Wrenchers Garage SP 09-25

WRENCHERS GARAGE SITE PLAN NO. 09-25-

PLAN REVIEW CENTER REPORT

SUBJECT: Wrenchers Garage and Restoration Shop, SP#09-25
Traffic Review of Preliminary Site Plan

44455 Grand River

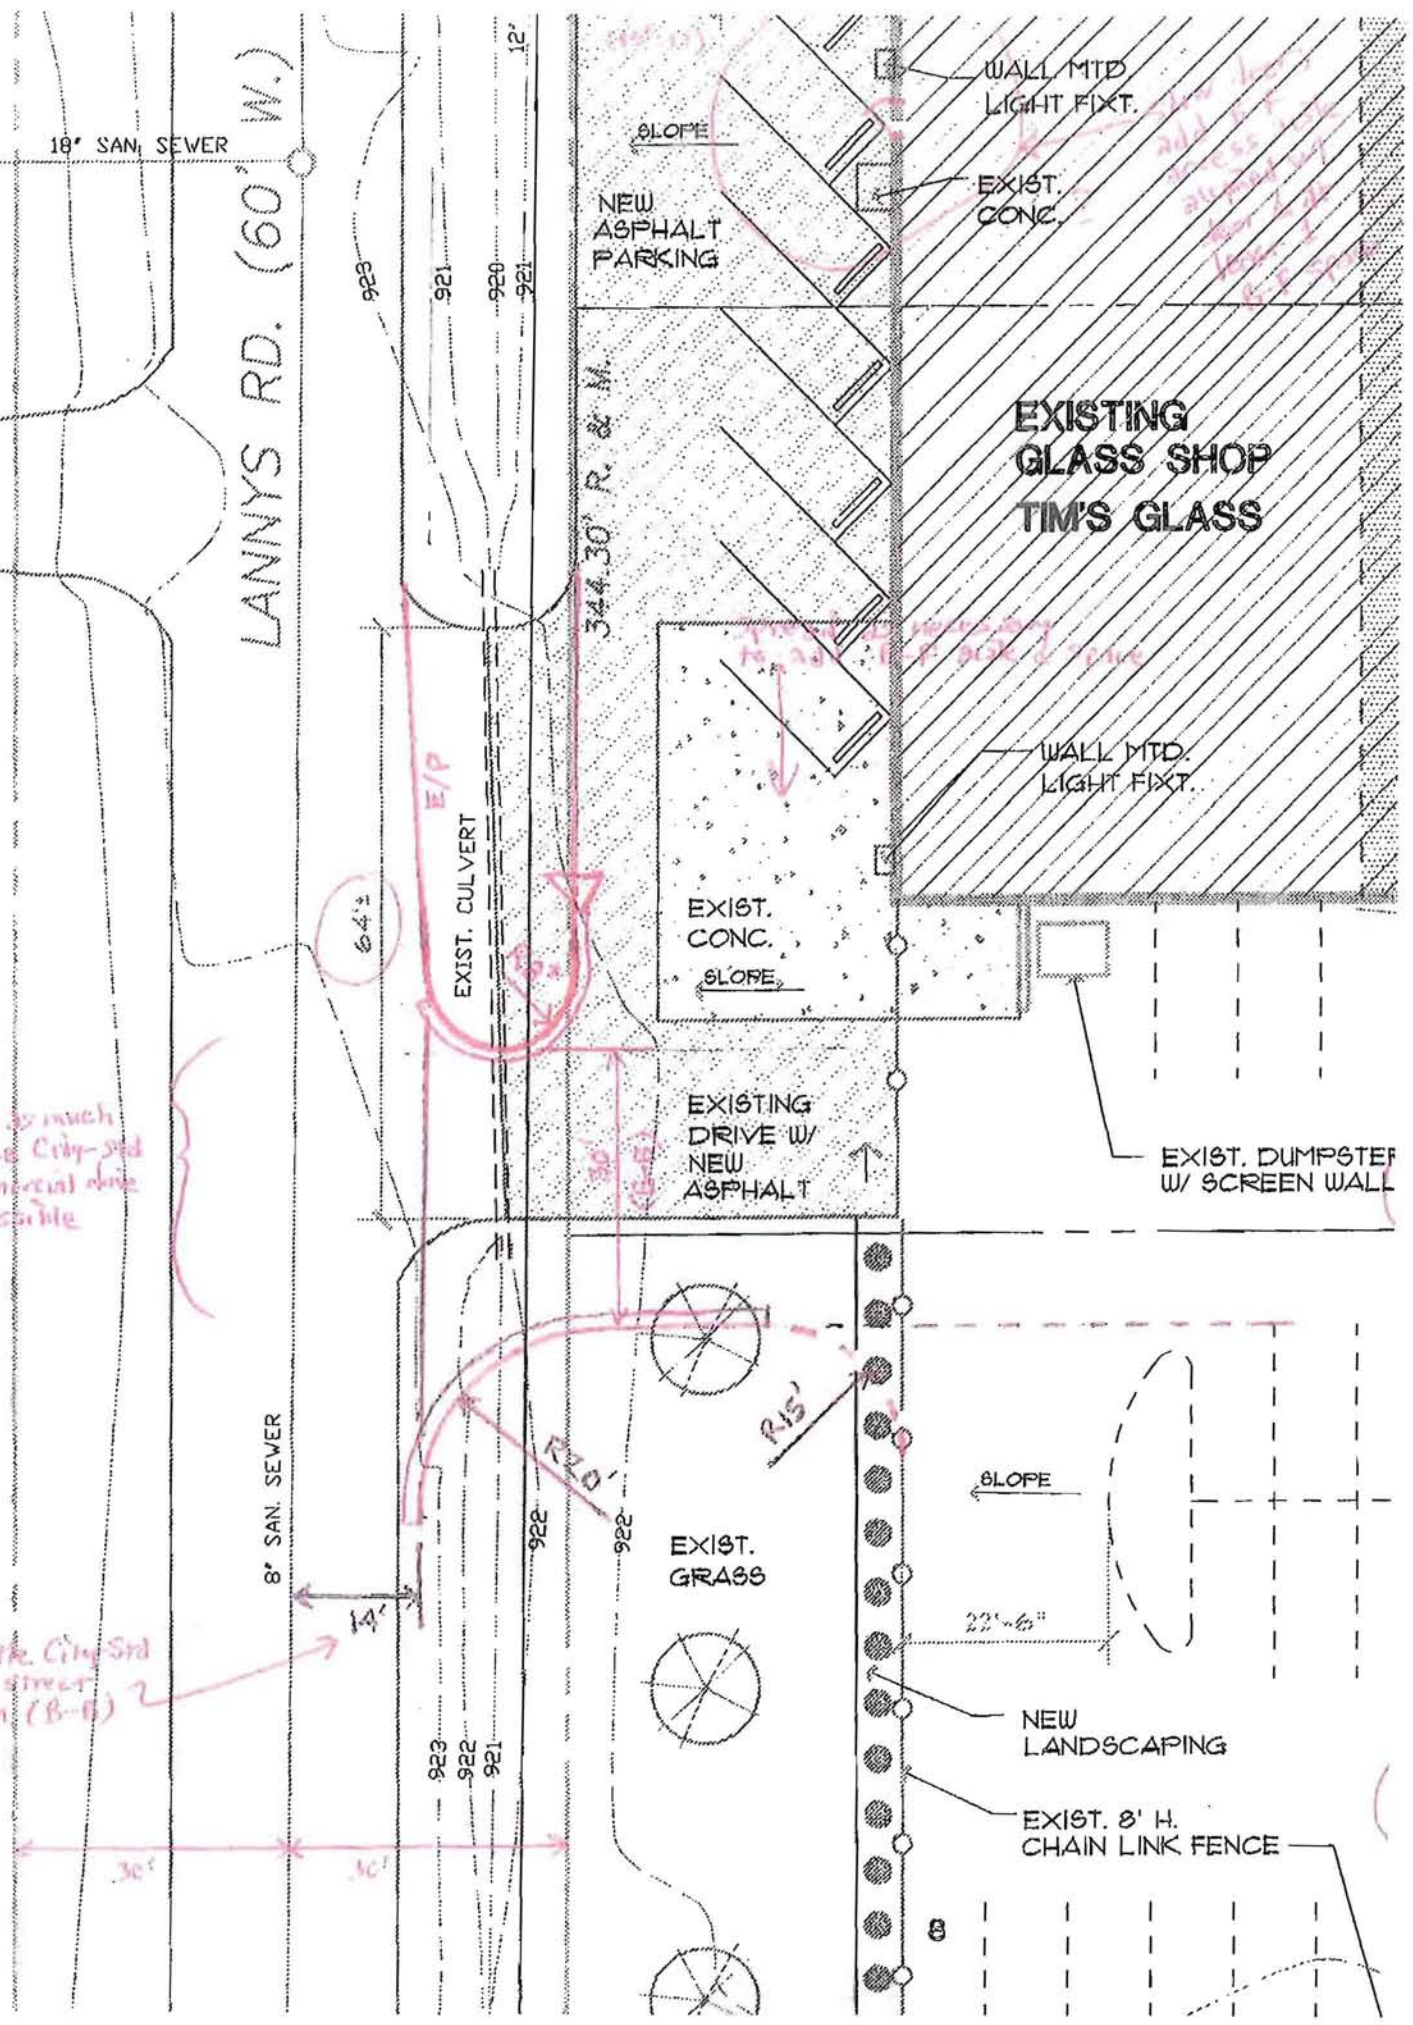
9. **The site access on Lanny's Road should be reconstructed as closely as possible to the City's commercial driveway standard. This will improve traffic flow and safety, and put to better use the paving expense already proposed in this area of the site. To optimize future circulation, the new driveway should be positioned so that its southern edge aligns with the south side of the land-**

Build as much of the City-Std commercial drive as possible

Half the City-Std local street width (B-B)

As recommended, the complete survey of existing conditions will be included in the final site plan approval document submission. The architectural site plan will also reflect all curb cuts within 200 ft. of the site. Regarding the move and changes to the Lanny's Road access to the site, we believe that we can accommodate most of the city standards and requirements. Unfortunately, the recommendation does not show consideration of

the overhead door located on the west side of the building. Moving the access point will considerably hinder accessibility and maneuverability of any large vehicles trying to enter the building. We can apply the correct standards to any future access construction but we would have to leave it in the current location.

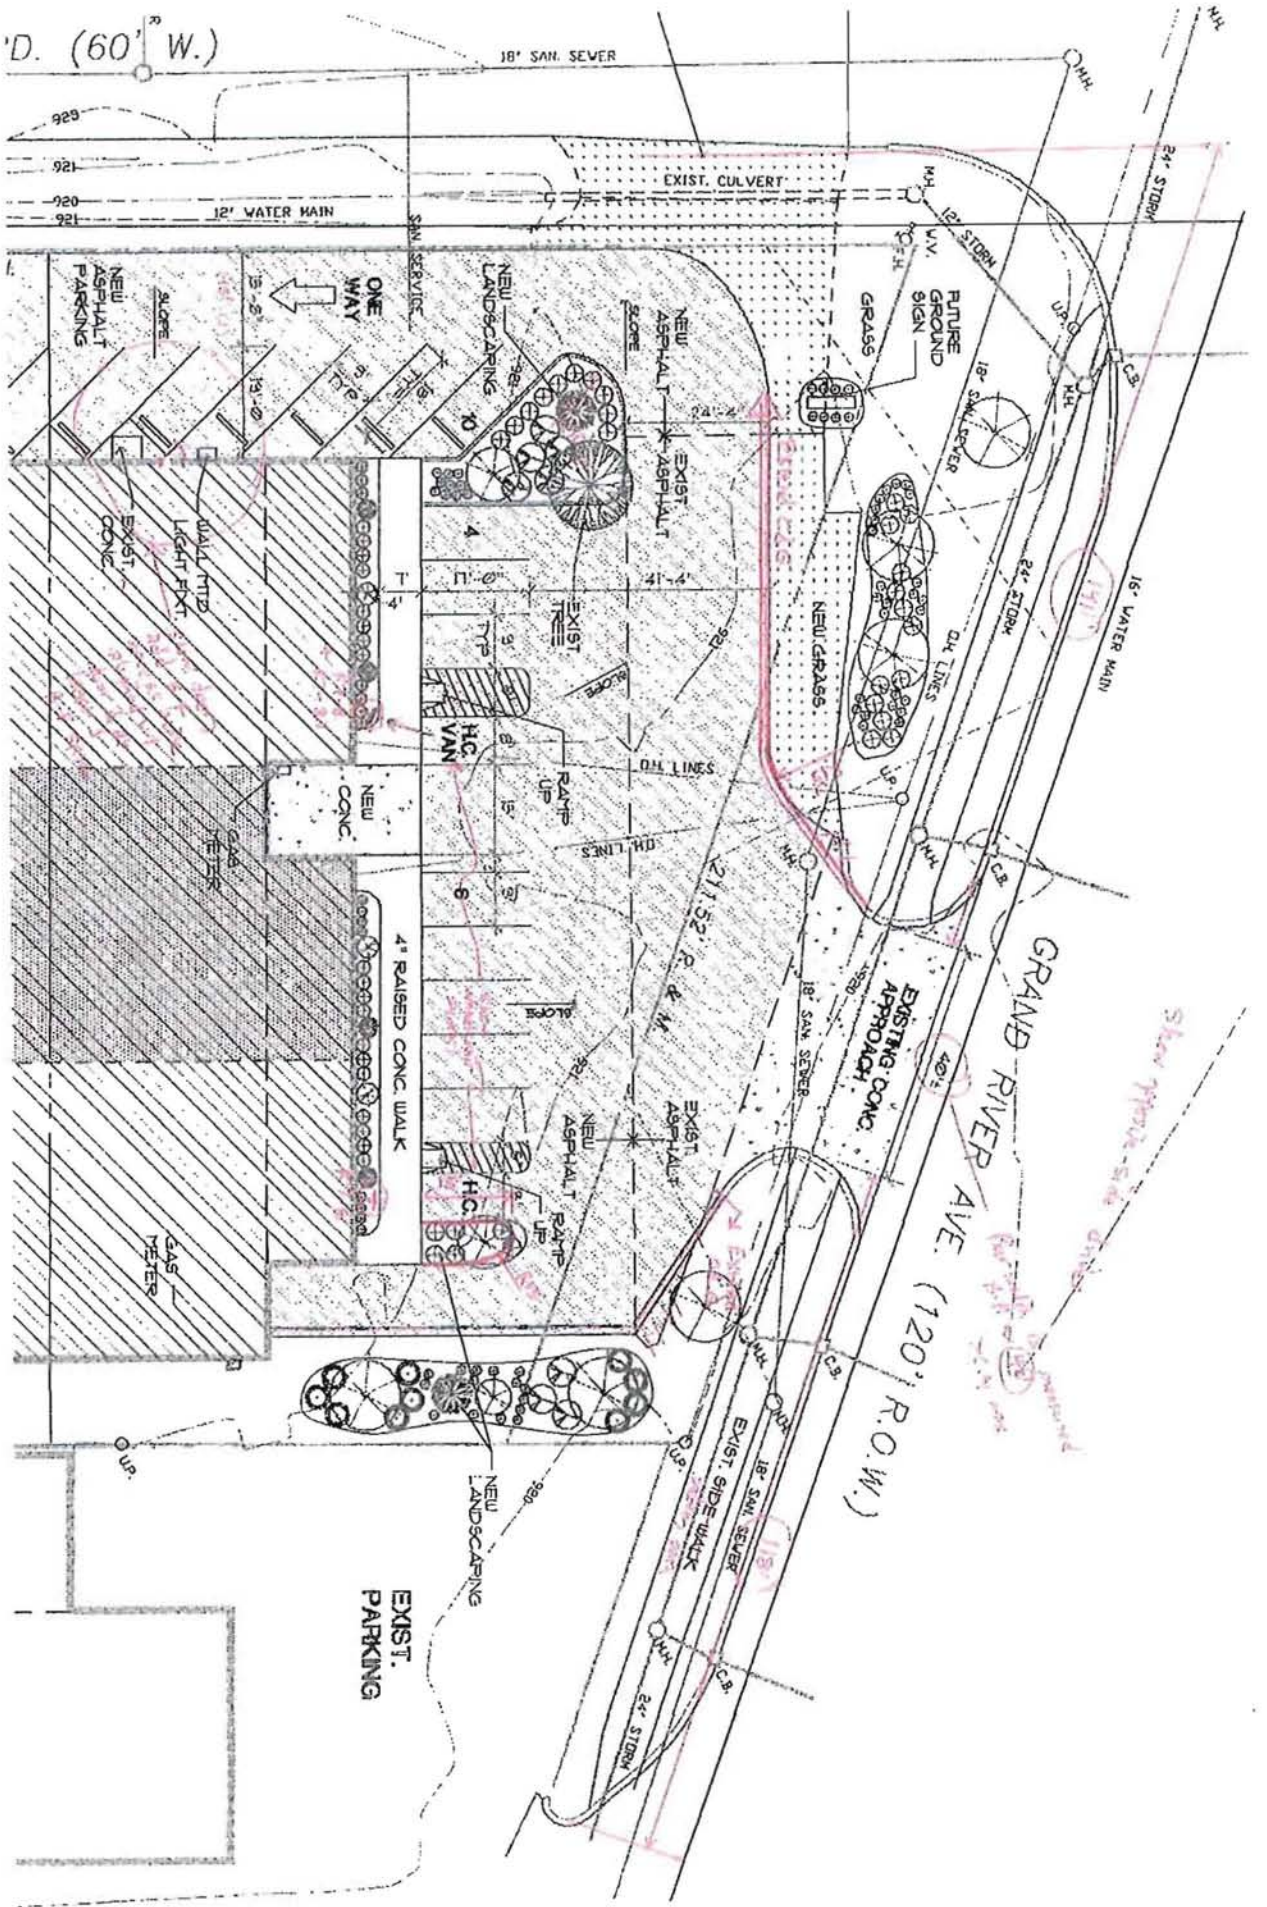
- 16. To avoid "dead" corners that will inevitably accumulate debris, the curb and gutter on either internal side of the Grand River driveway should be aligned as shown in the second attached plan mark-up.**

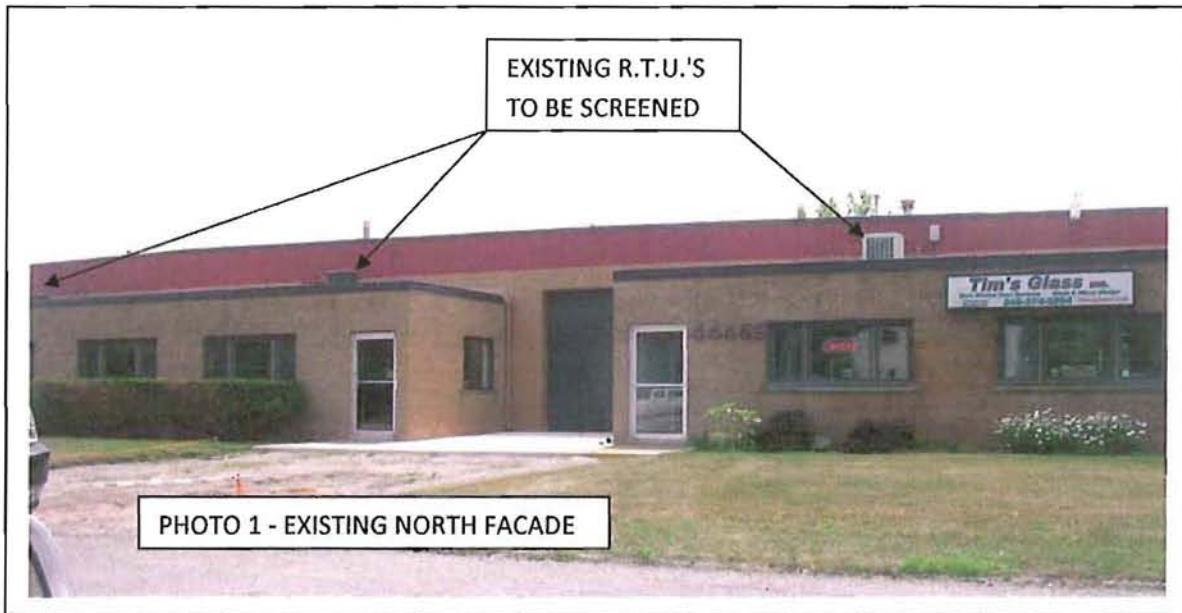
Comments: As shown above the percentage of Painted Concrete Masonry Units (C.M.U.) exceeds the ordinance maximum on the north facade, and the percentage of Ribbed Metal Panels exceeds the Ordinance maximum on the north, west and east facades. The C.M.U. located on the north facade represents an existing material and no additional C.M.U. is proposed. The Ribbed Metal Panels are used to screen existing and somewhat unsightly rooftop mechanical equipment (R.T.U's) currently visible on the north, west and east facades. It should be noted that the design can be brought into compliance with respect to the roof equipment screens by using Flat Metal Panels in lieu of Ribbed Metal Panels. The applicant has noted that the proposed metal roof, equipment screens and trim and existing overhead doors will be "painted red to match building".

It is assumed that all new red paint will match the subdued red color presently found on the north facade (Photo 1, below). The use of bright red color would not be consistent with the section 2520.2 of the Ordinance which prohibits the use of dissonant and/or intense colors.

(C.1) SITE PLAN
 SCALE: 1" = 20'

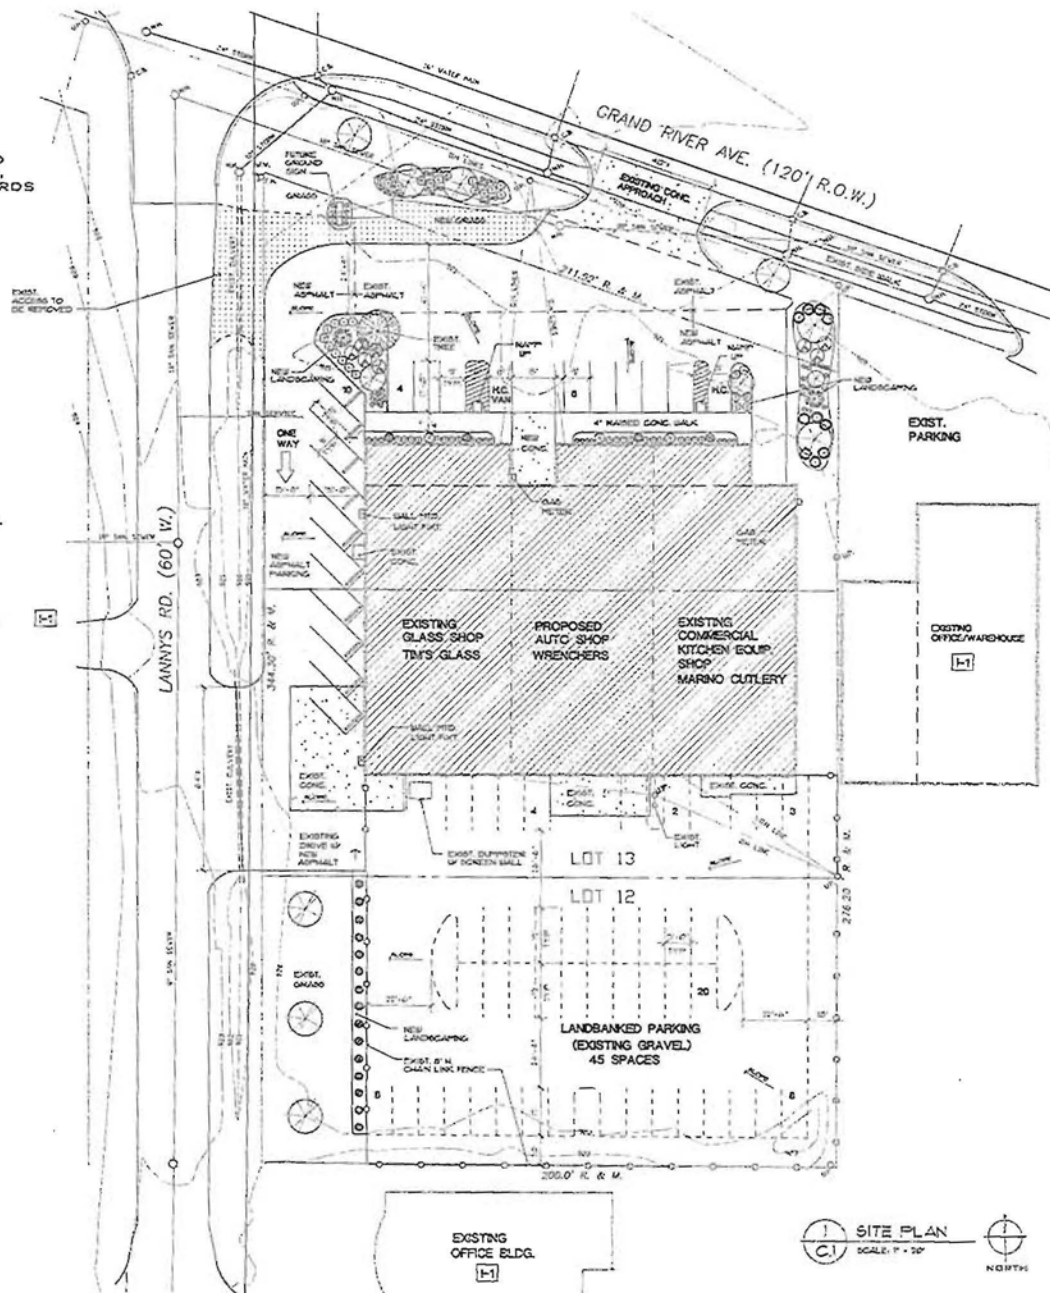
12. According to the floor plan (sheet A.1), there is a service door on the west façade 29 ft south of the northwest building corner. This door is not shown on the architectural site plan (sheet C.1), nor does it line up with the small concrete pad shown on the latter sheet. **The door's location should be accurately shown on sheet C.1. To provide reasonable and safe building access at this location, a barrier-free access aisle should be aligned with the door, a ramp provided if necessary to reach the elevation of the threshold, and the angled parking spaces shifted south as necessary to make room for the access aisle and the one additional barrier-free space indicated in comment 12 as eventually being necessary.**
